In response to your request dated June 28, 1976, the Commission has issued the enclosed Amendment No. 14 to Facility License No. DPR-51 for the Arkansas Nuclear One - Unit No. 1 facility.

This amendment revises control rod withdrawal limit curves (Figures 3.5.2-1B and 3.5.2-1C) to establish a  $\pm 10$  effective full power day (EFPD) band when switching between the two curves at 435 EFPD.

ARKANSAS NUCLEAR ONE - UNIT NO. 1

Amendment No. 14  
License No. DPR-51

FIG. NO.  
3.5.2-1B

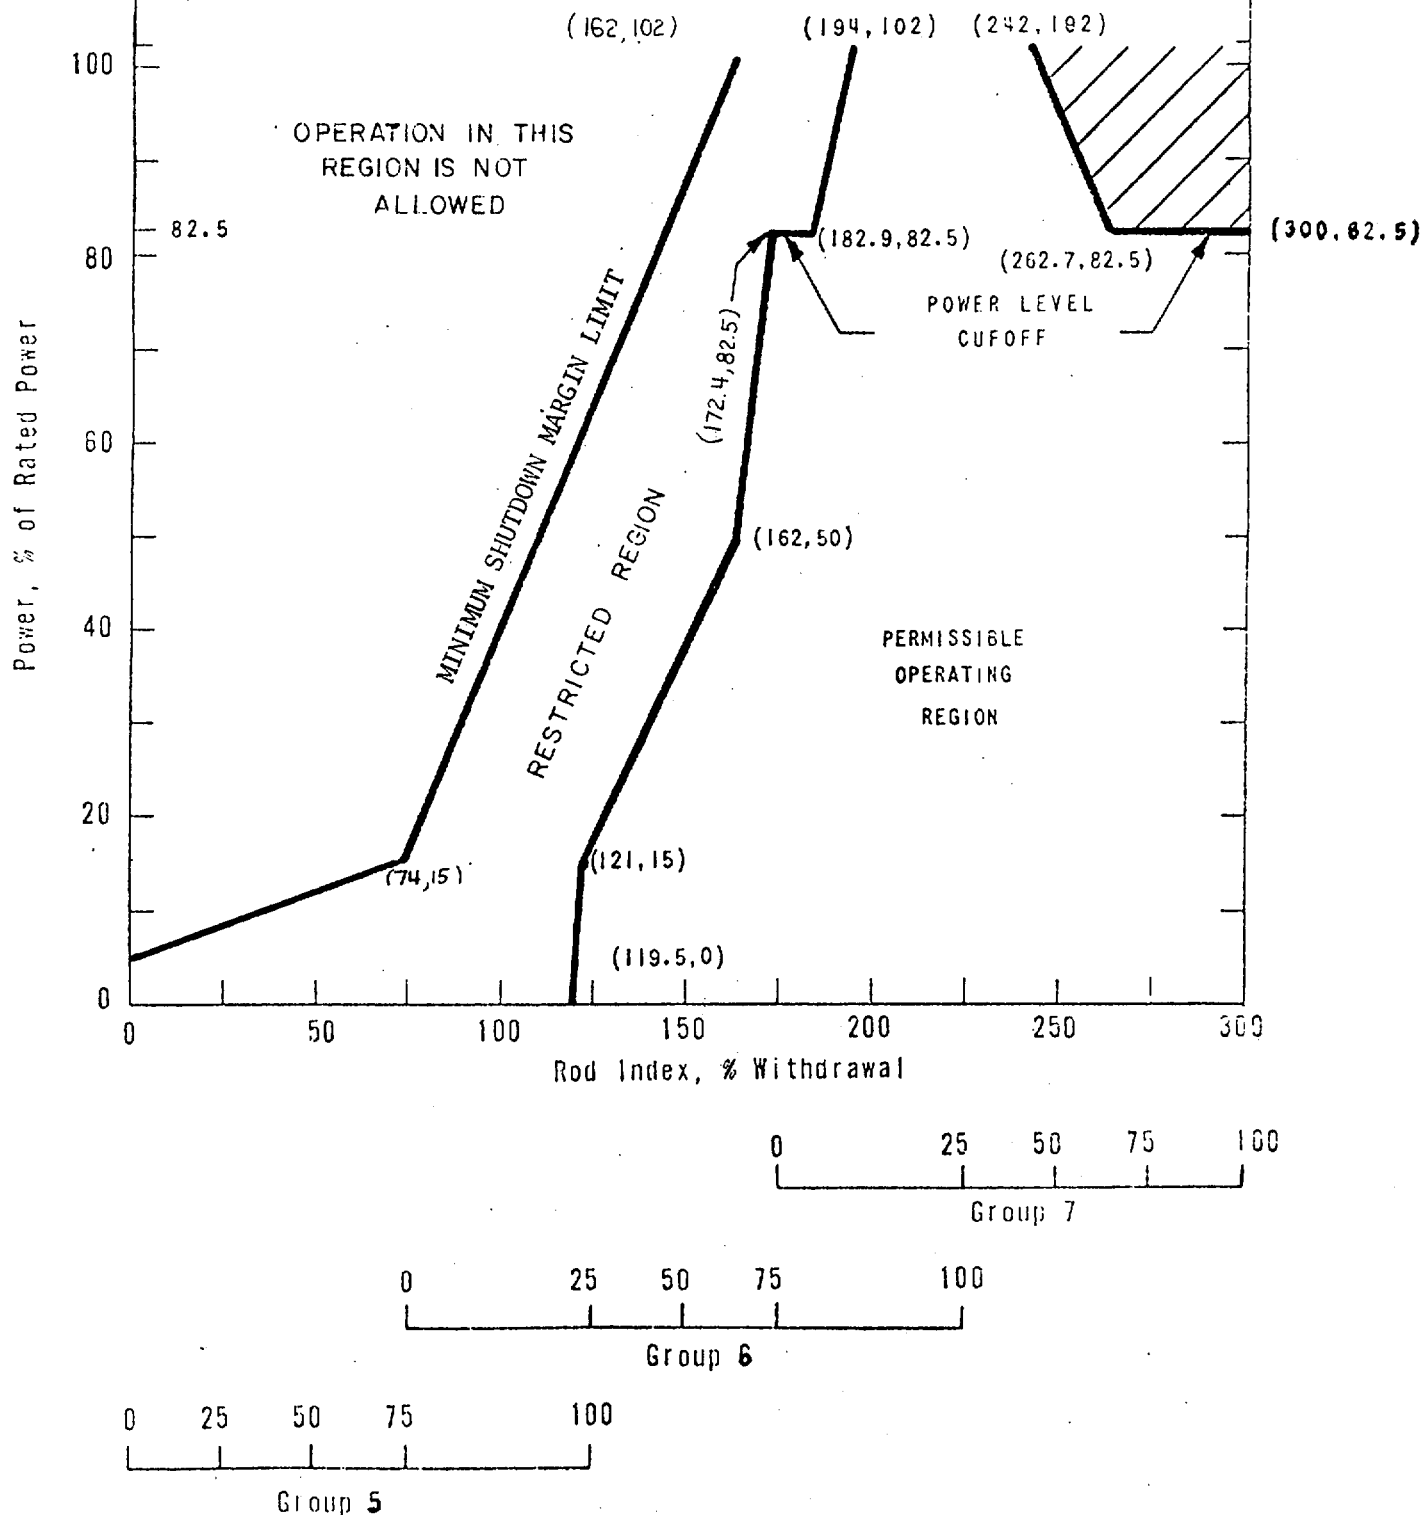
1. Rod index is the percentage sum of the withdrawal of the operating groups.
2. The additional restrictions on withdrawal (hashed areas) are in effect after the control rod interchange. The restrictions on withdrawal are further modified after 435  $\pm$  10 full power days of operation (See Figure 3.5.2-1C)

FIG. NO.  
5.5.2-1C

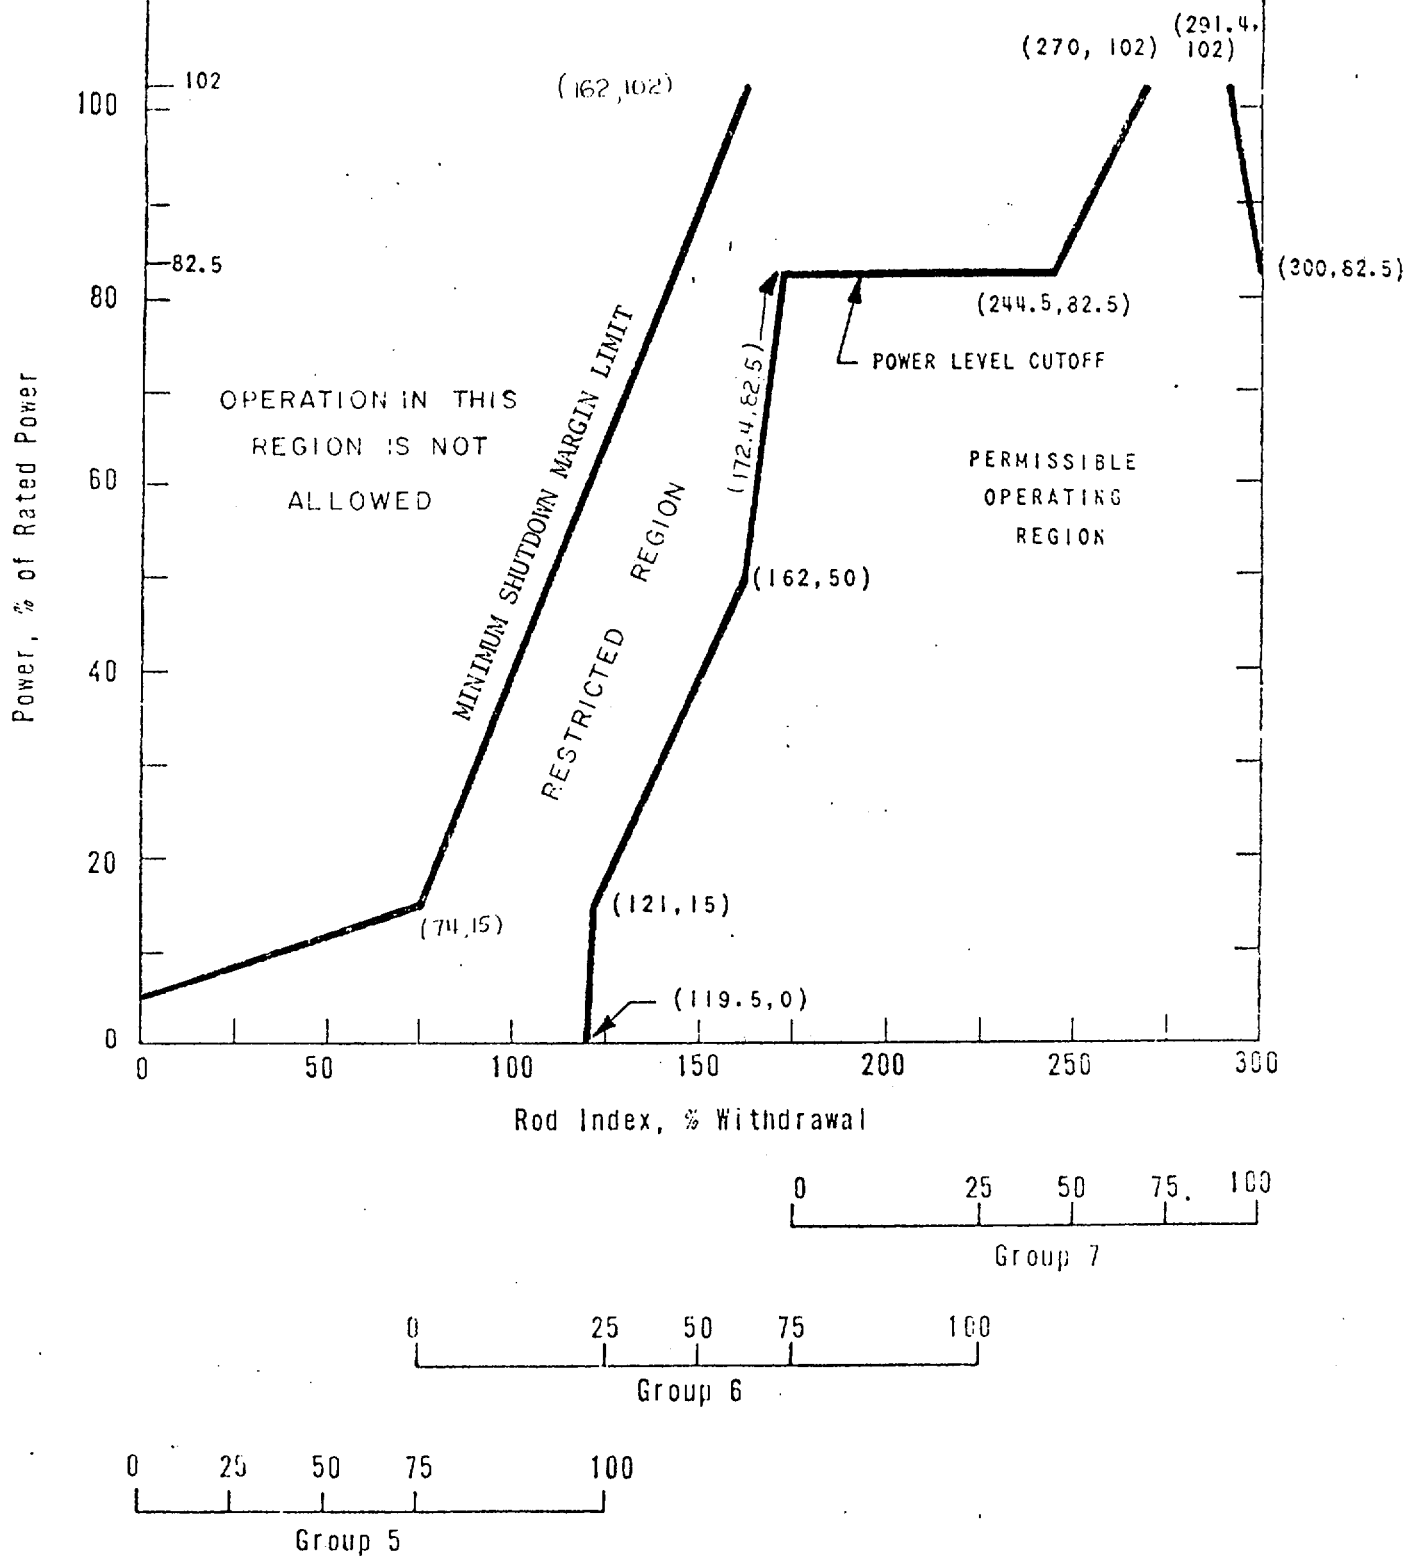
2. The additional restrictions on withdrawal are in effect after  $435 \pm 10$  full power days of operation.
